Ventura County Community College District

SUBJECT: Addendum 2 – Bid 594 Fire Technology Apparatus Building Rough Grading and

Storm Drain Improvements

The attached reduced <u>Academy Rough Grade Clouded Drawings</u> have been added to this project and is posted on our website in full size format.

COUNTY OF VENTURA PUBLIC WORKS AGENCY **DEVELOPMENT & INSPECTION SERVICES** RAS5923 IMPROVEMENT PLAN COVER SHEET - ROUGH GRADE

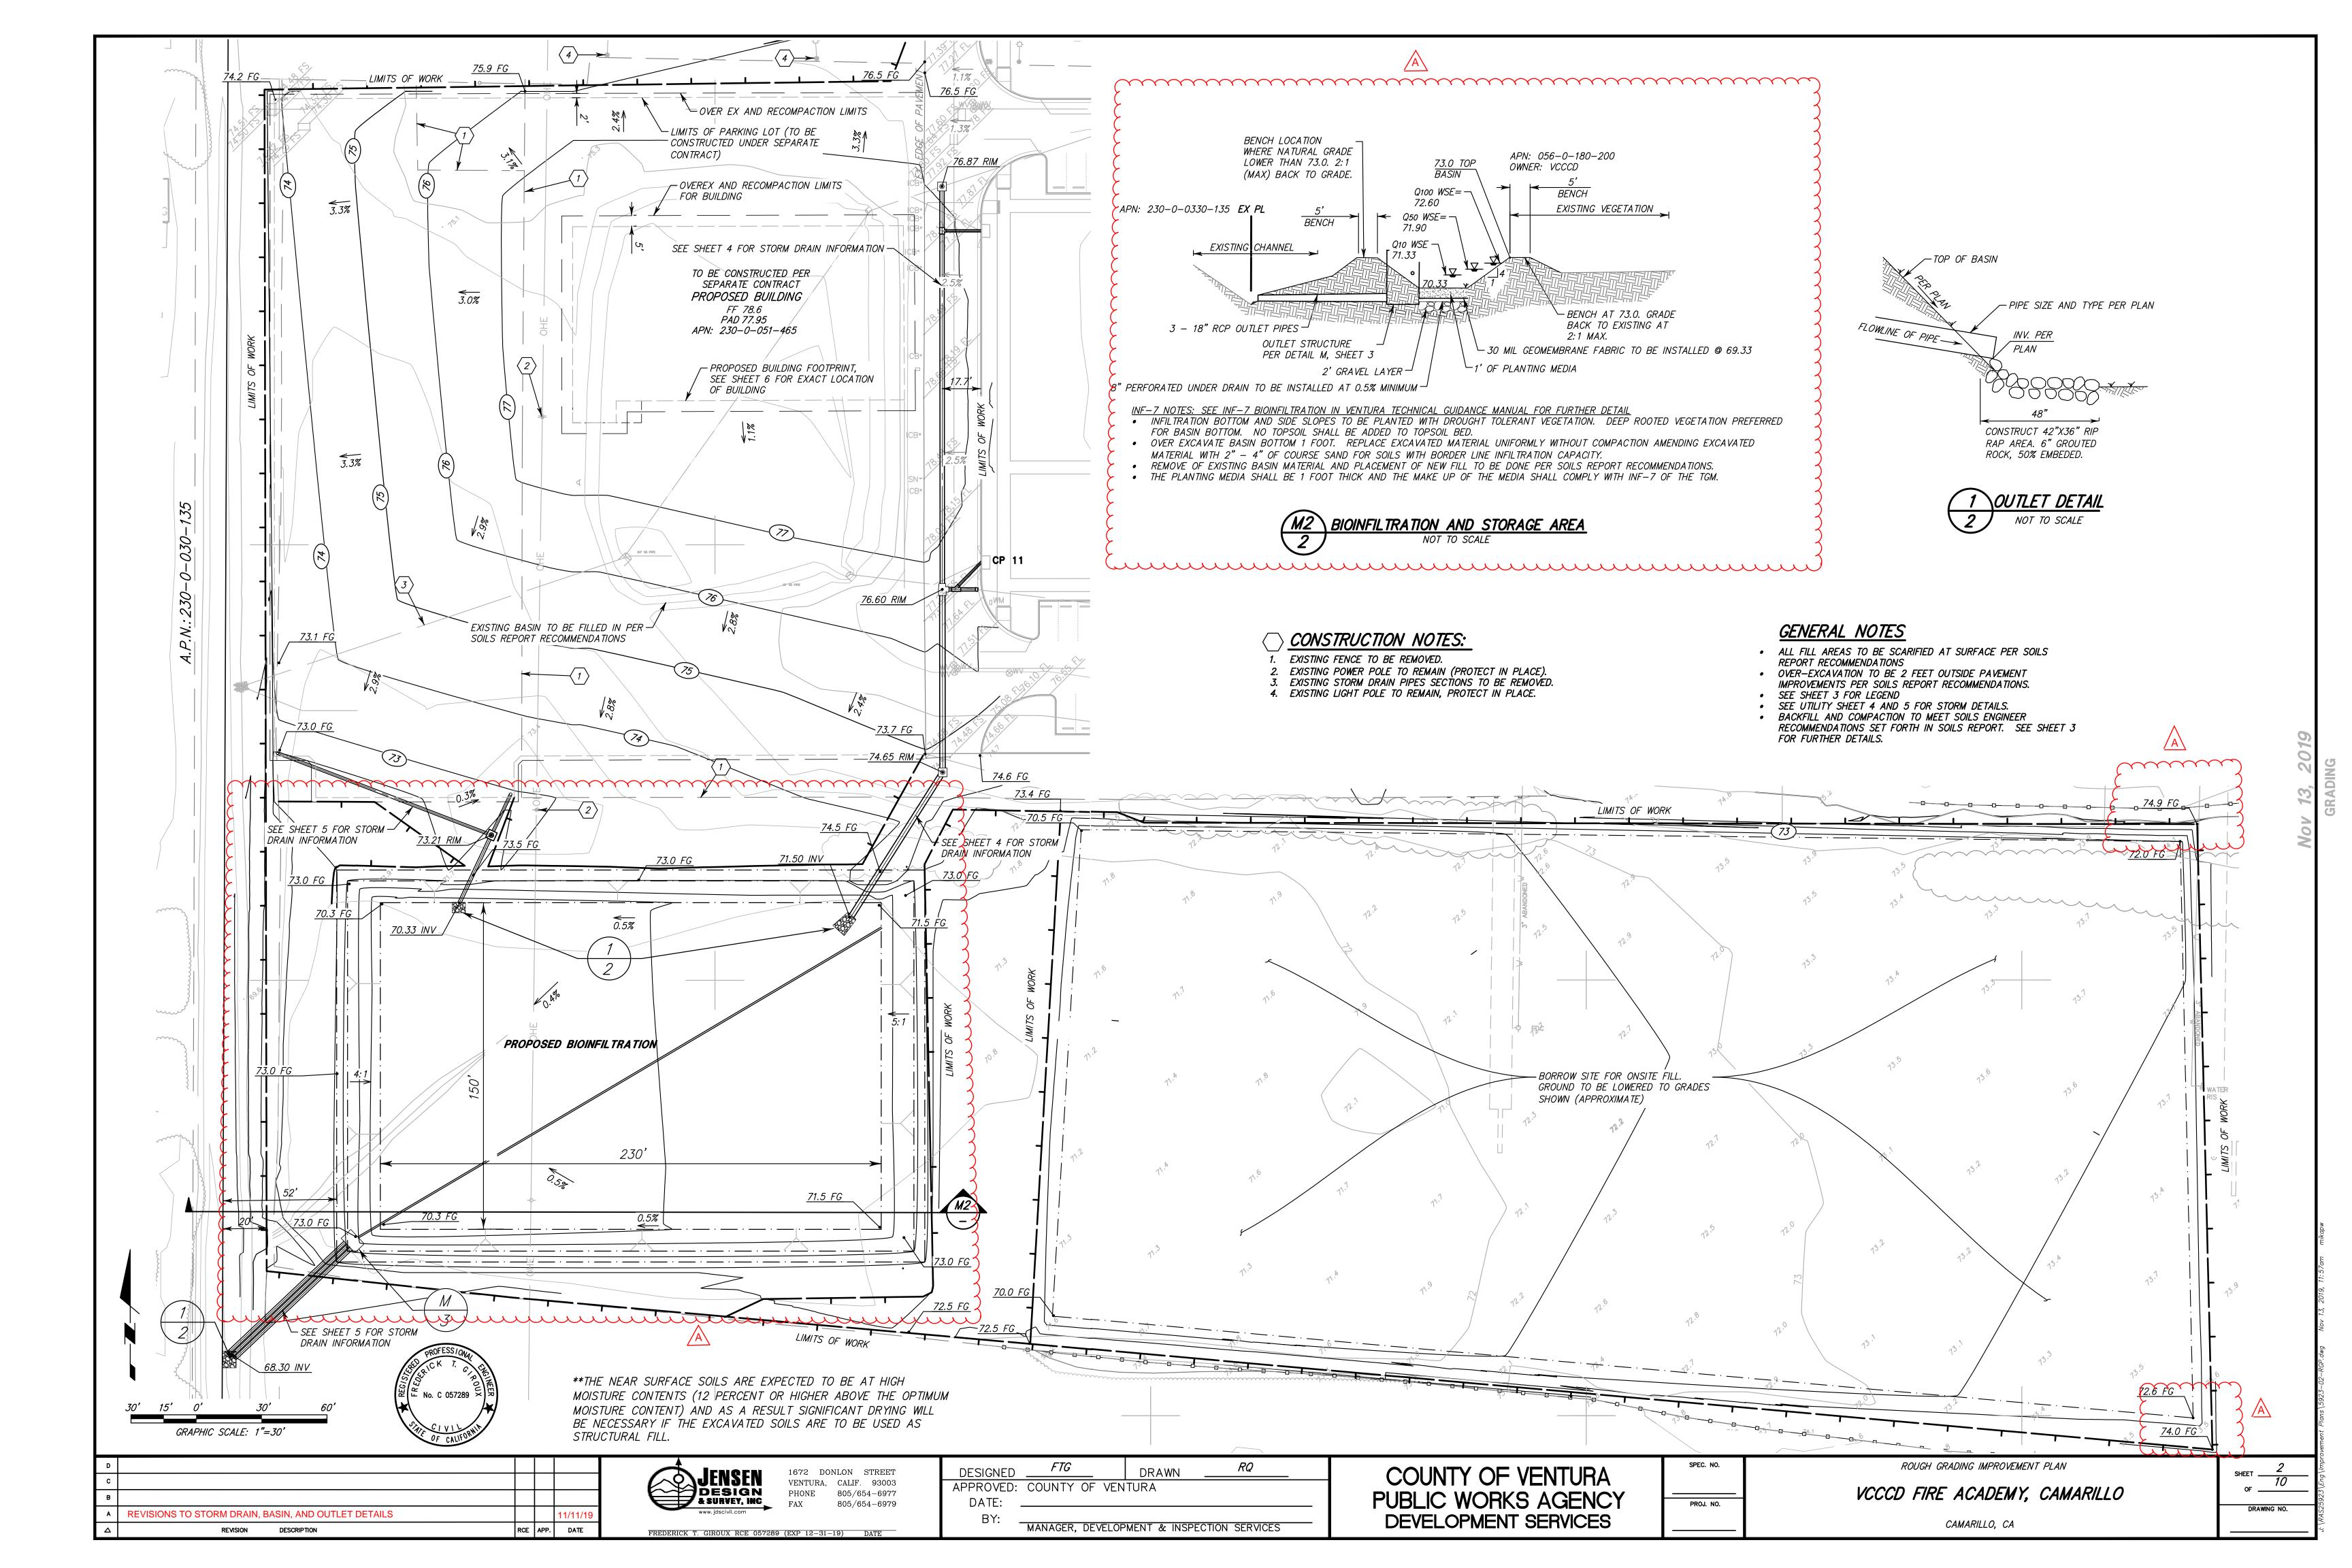
EVISIONS TO STORM DRAIN, BASIN, AND OUTLET STRUCTURE

ROUGH GRADING IMPROVEMENT PLAN

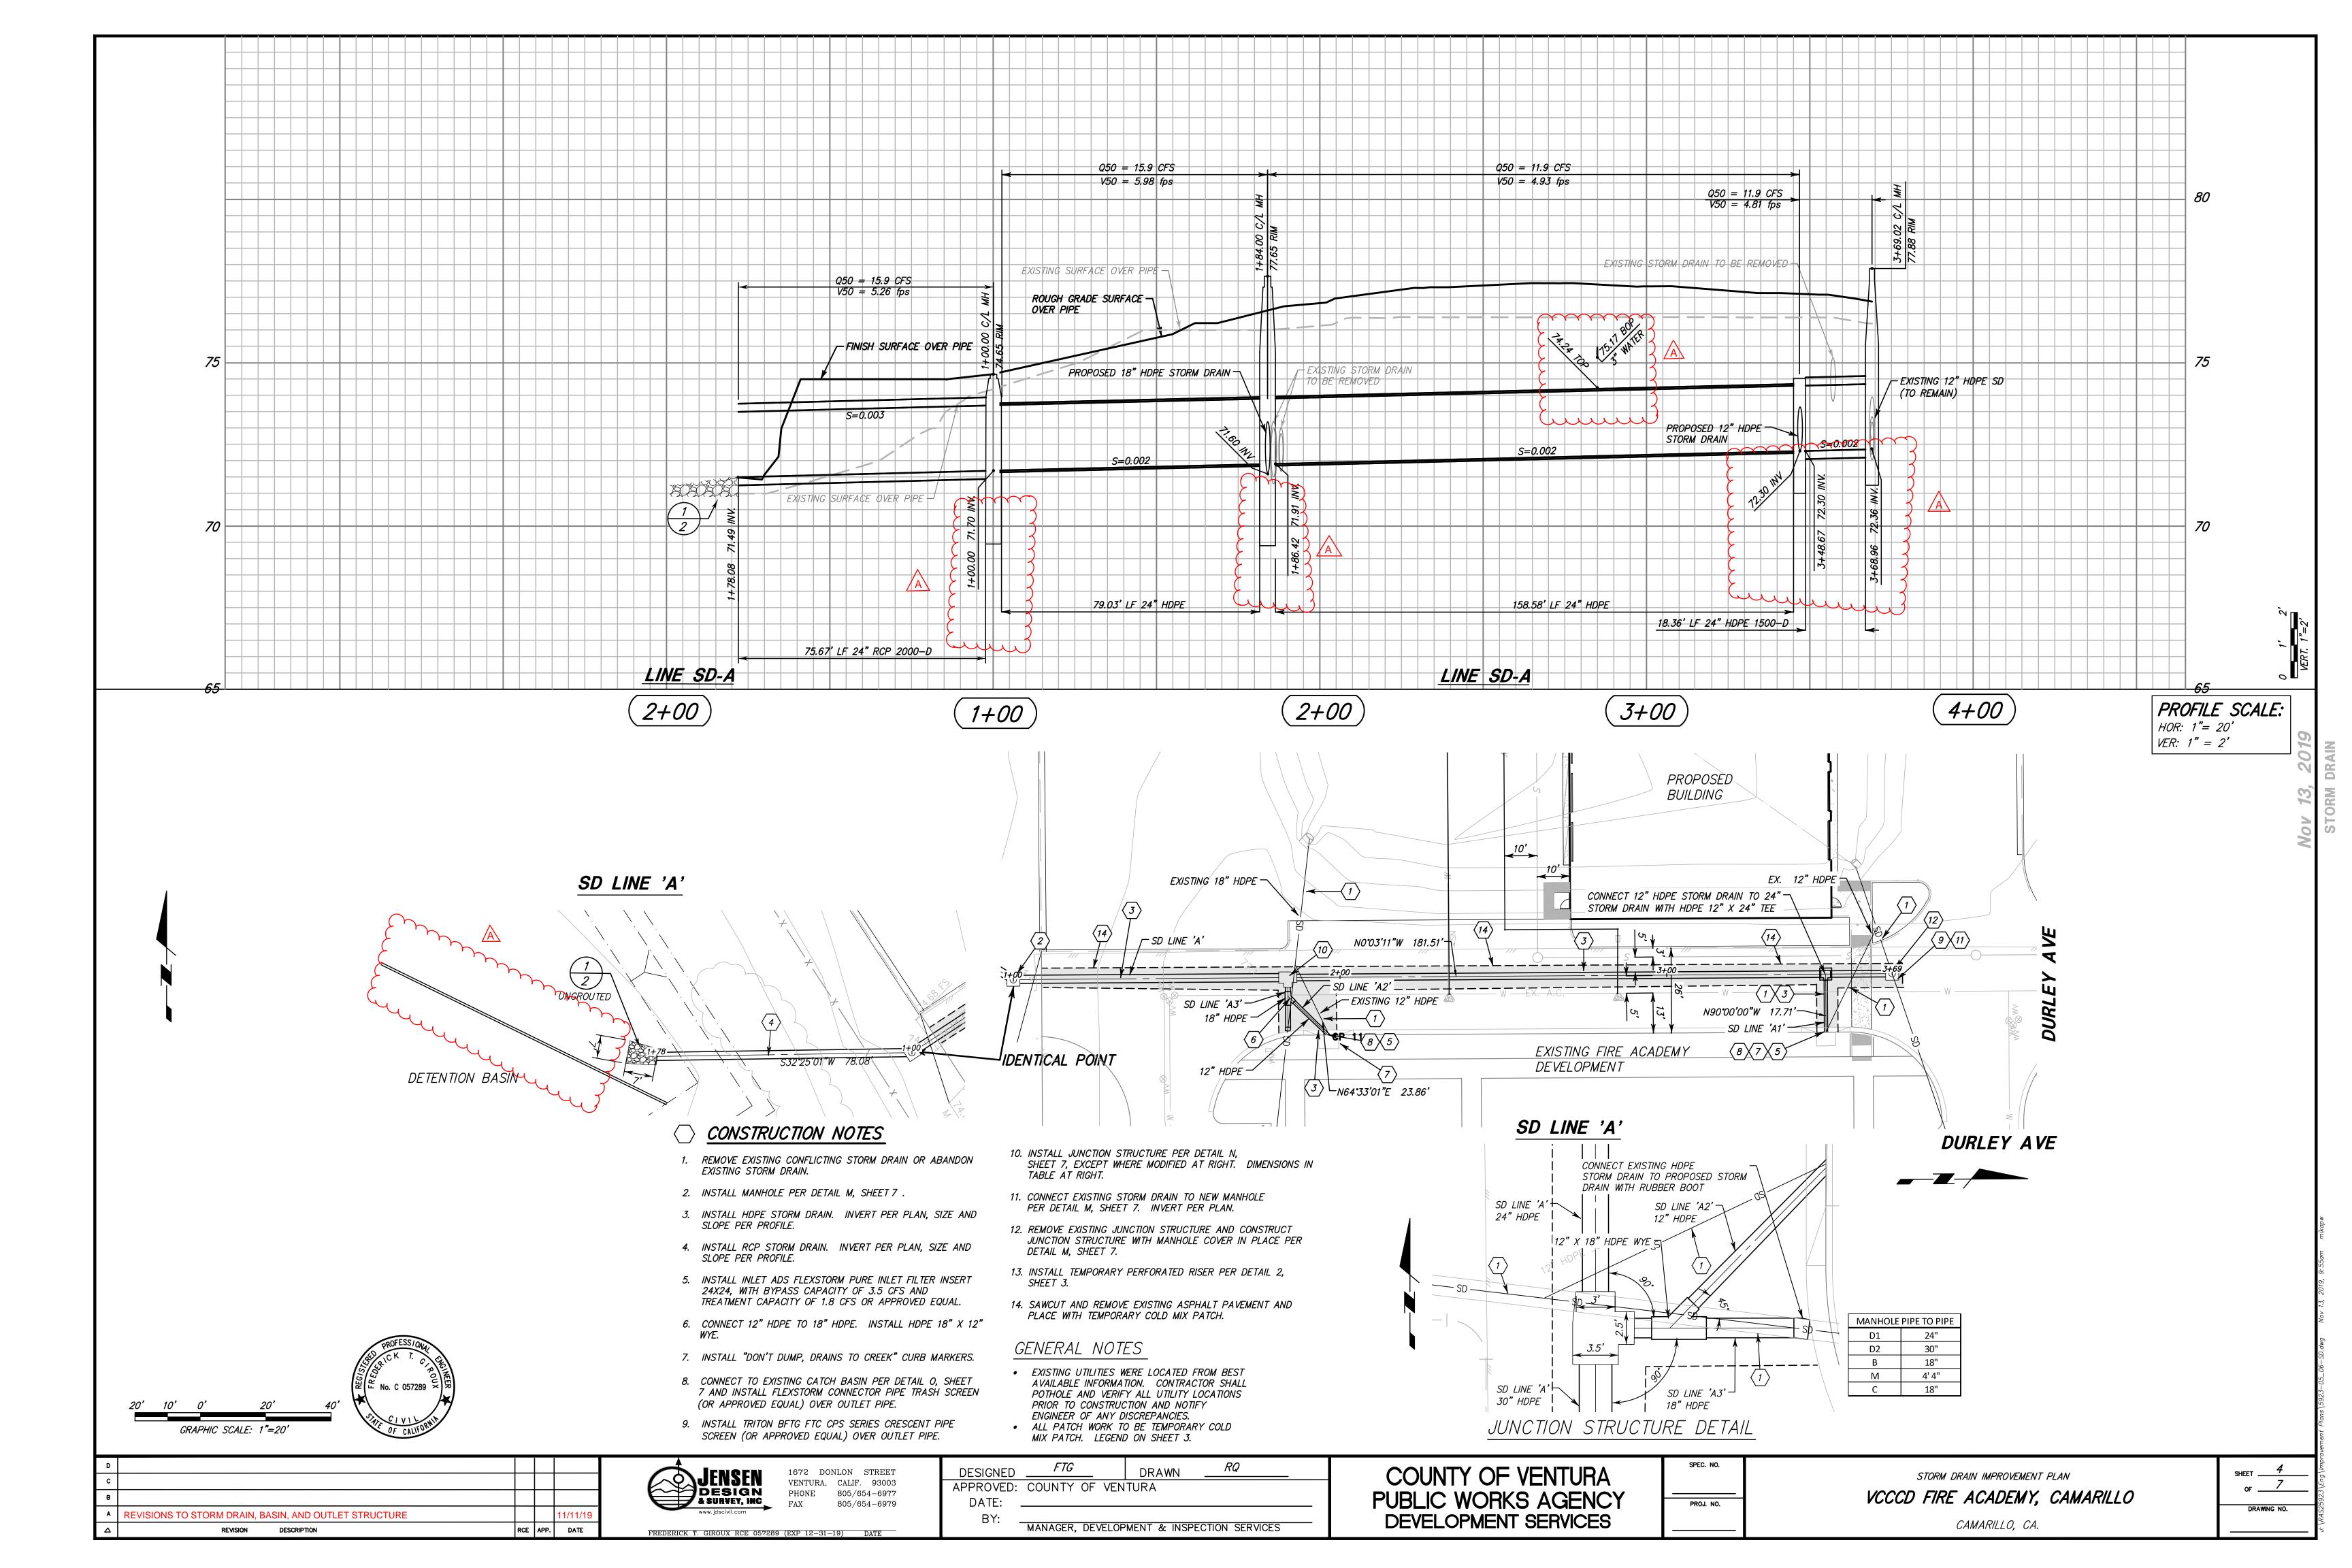
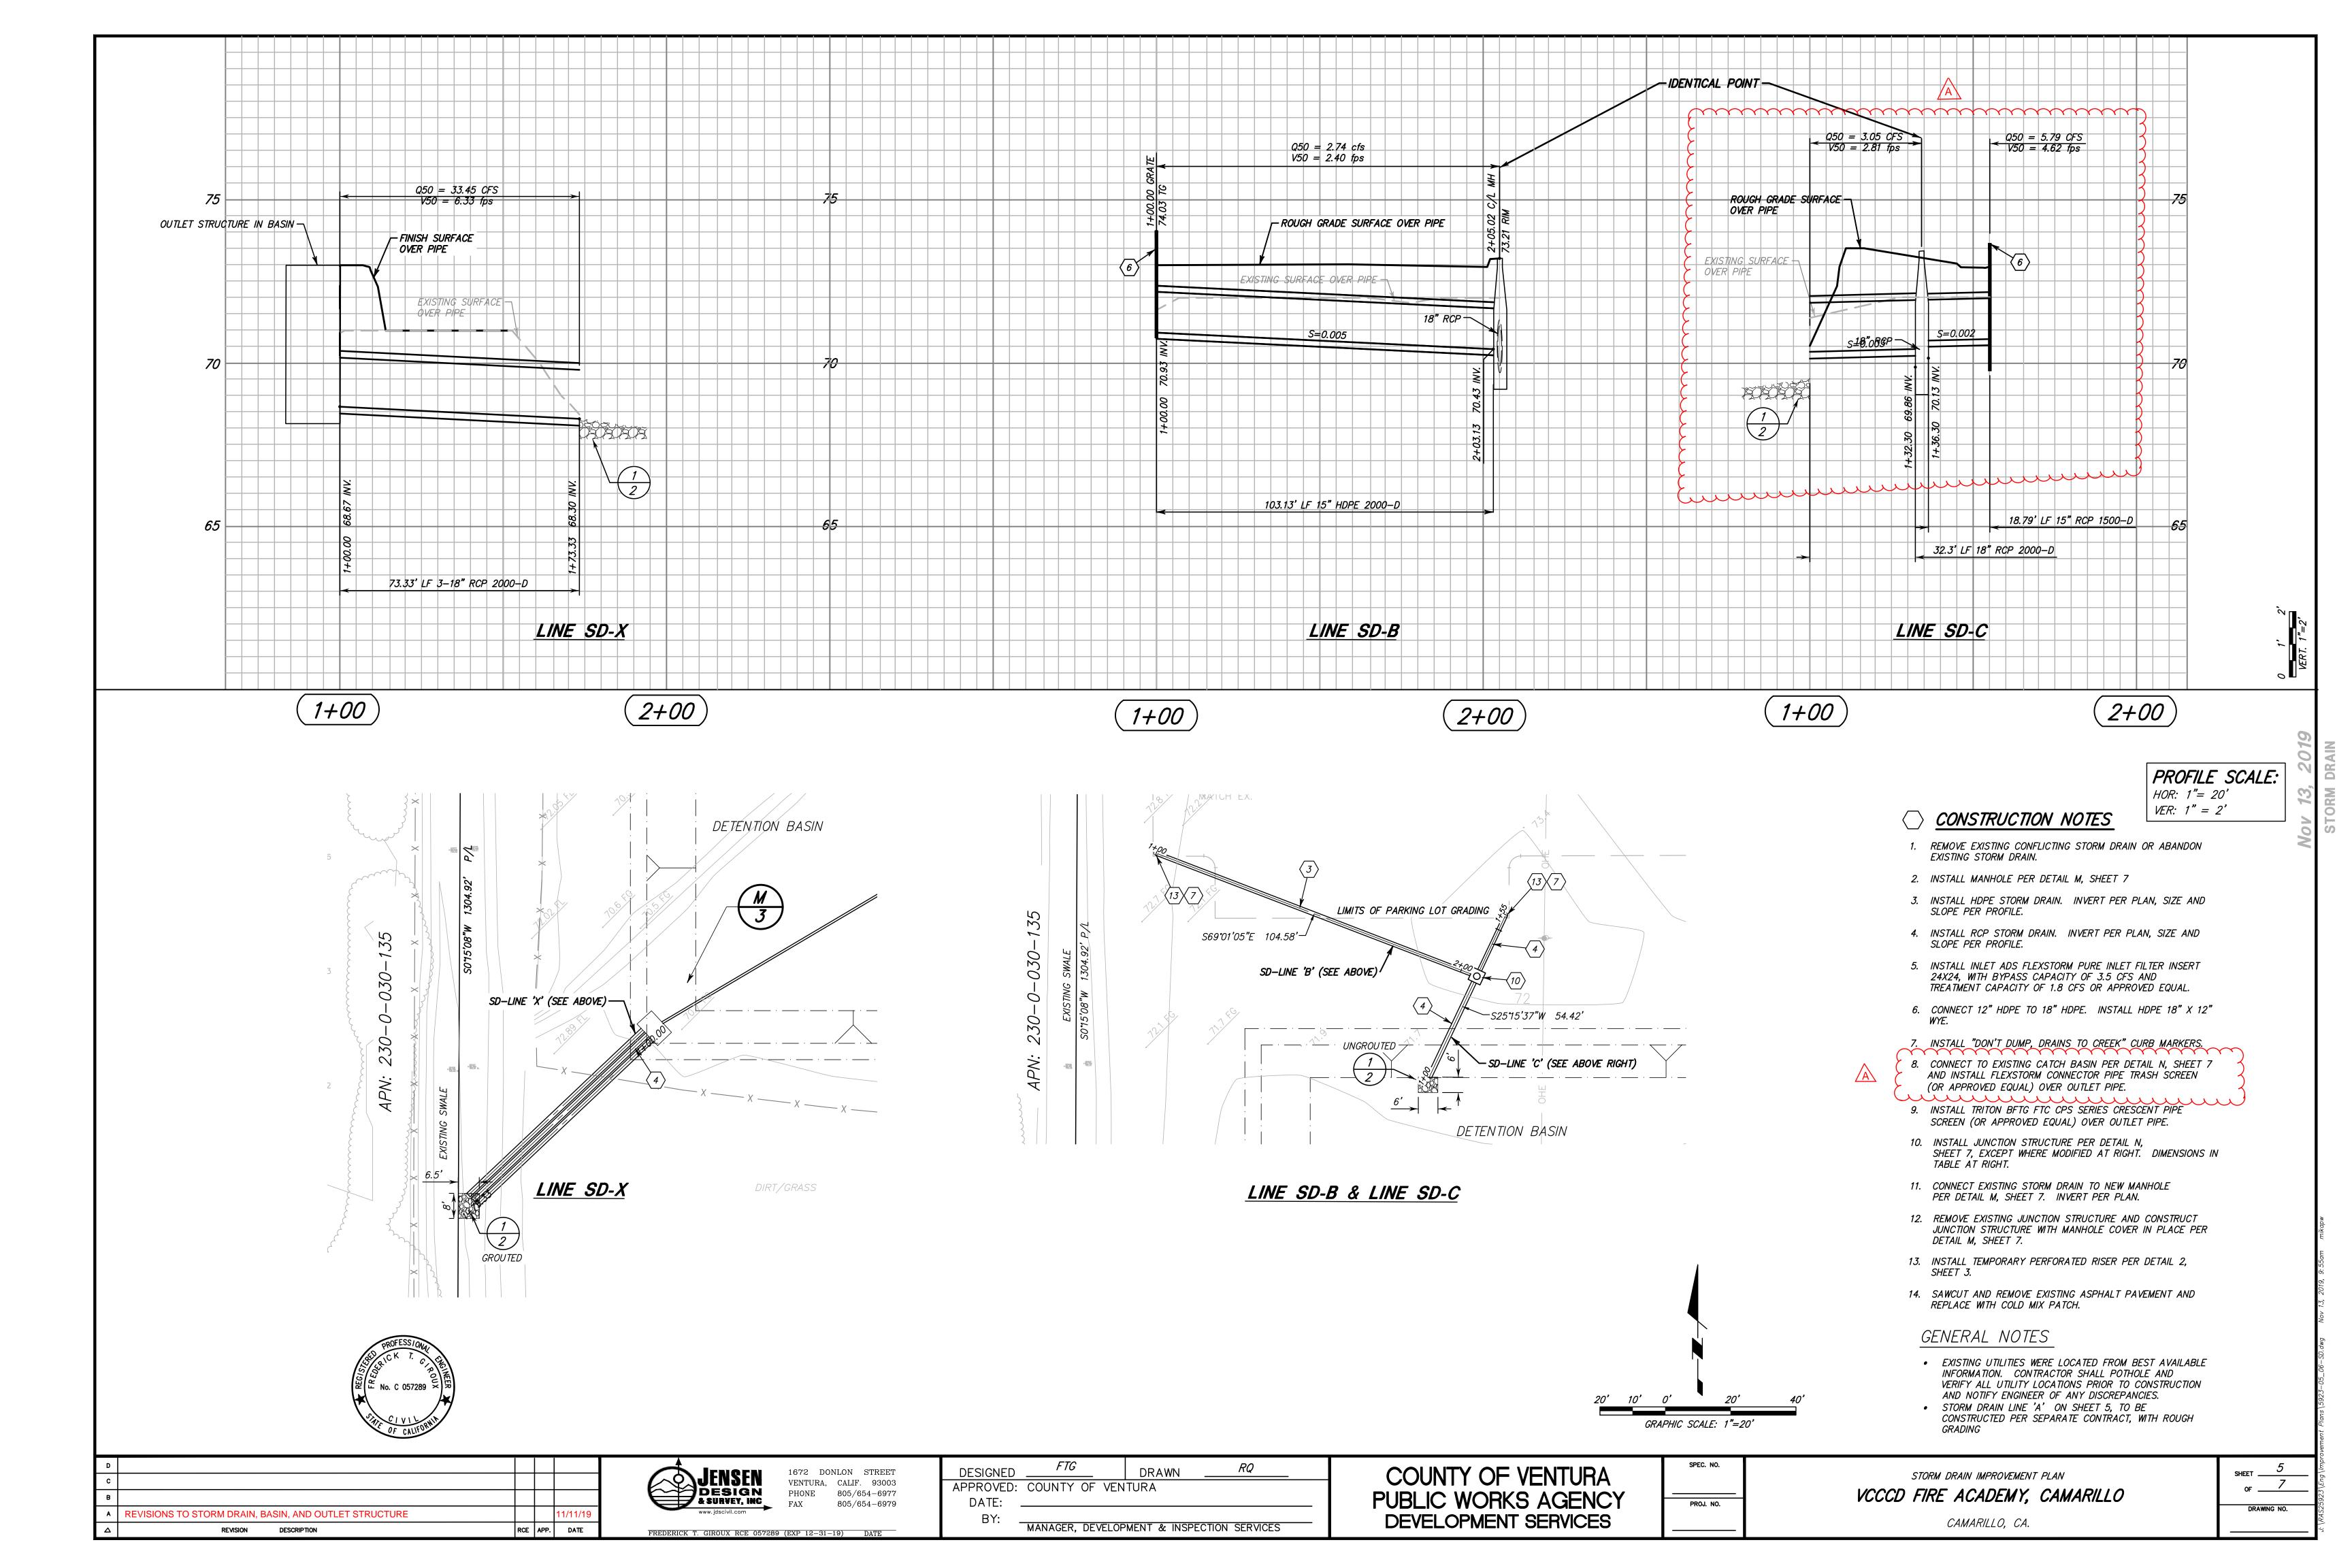
REVISIONS TO STORM DRAIN, BASIN, AND OUTLET STRUCTURE 11/11/	_
C	١.
